Vibration at Idle in Park

YEAR(S)	MODEL(S)	ADDITIONAL INFORMATION
2015 - 2017	NX200T

Some 2015 – 2017 model year NX 200t vehicles equipped with 8AR-FTS engines may exhibit an abnormal vibration at idle in Park. The Engine Control Module/ECM (SAE Term: Powertrain Control Module/PCM) logic has been modified to reduce the possibility of this condition occurring. Follow the Repair Procedure in this bulletin to address this condition.

Figure 1. Location of Authorized Modifications Label on 2015 – 2017 NX 200t

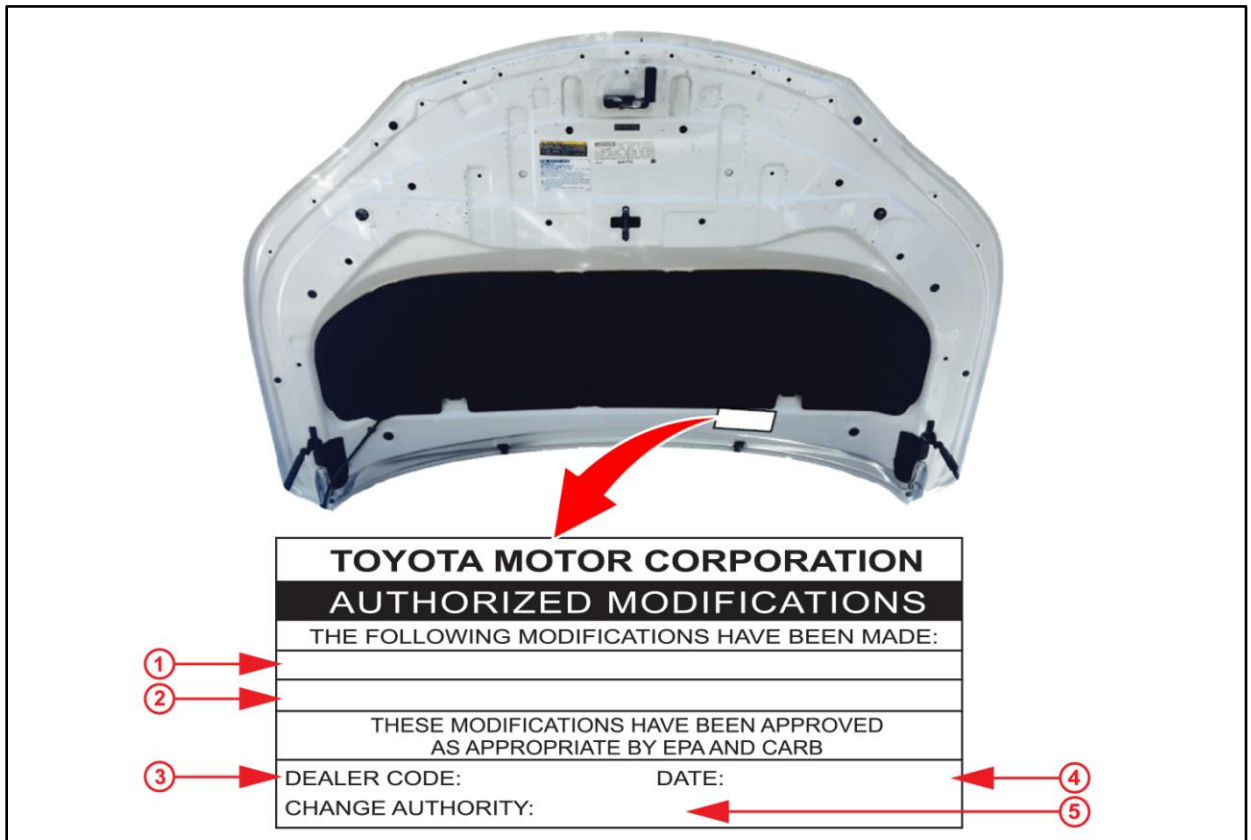
- Check for the Authorized Modifications Label affixed to the vehicle in the location shown below. Confirm if the ECM (PCM) calibration has been updated.

Is the calibration ID listed NOT the latest ECM (PCM) calibration?

- Prepare and install the Authorized Modifications Label.
 - Using a permanent marker, enter the following information on the label:
 - ECM part number [Refer to the **Parts Information** section for the **NEW PART NUMBER**]
 - Calibration ID(s) [Refer to the **Calibration Information** section for the **NEW CALIBRATION ID**]
 - Dealer Code
 - Repair Date
 - Change Authority [**This bulletin number**]
 - Install the Authorized Modifications Label to the vehicle at the location shown in Figure 1. The Authorized Modifications Label is available through the MDC, P/N 00451-00001-LBL.
- Verify the vibration condition is no longer present.
